# Service Bulletin

Bulletin No.: 22-NA-155

**Subject:** Harsh Transmission Downshift 4-3

Brand:	Model:	Model Year:		VIN:		Engine:	Transmission:
		from	to	from	to		
Chevrolet	Express	2020	2020			LV1	M5U, MQD
GMC	Savana	2020	2020

6131394

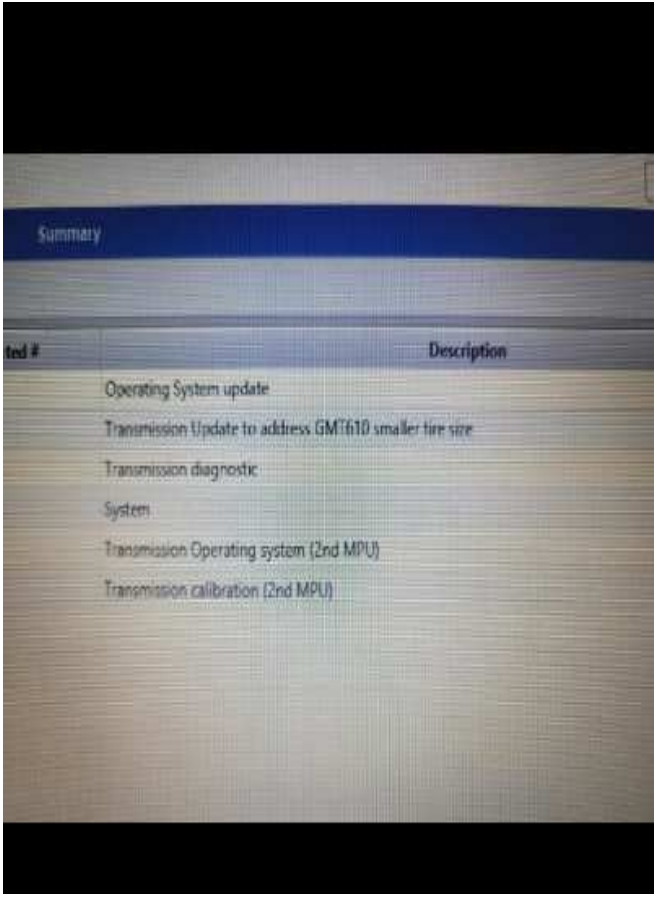
<b>Involved Region or Country</b>	United States, Canada, Mexico
<b>Additional Options (RPOs)</b>	
<b>Condition</b>	Some customers may comment on a harsh/hard transmission 4th to 3rd downshift.
<b>Cause</b>	The cause of the condition may be software anomalies in the transmission and may be elevated with customer driving habits.
<b>Correction</b>	<p>Update the TCM (Transmission Control Module) with "Transmission update to address GMT610 smaller tire size".</p>

<table><tr> <th>Updated #</th> <th>Description</th> </tr><tr> <td></td> <td>Transmission Update to address GM7610 smaller tire size</td> </tr></table>
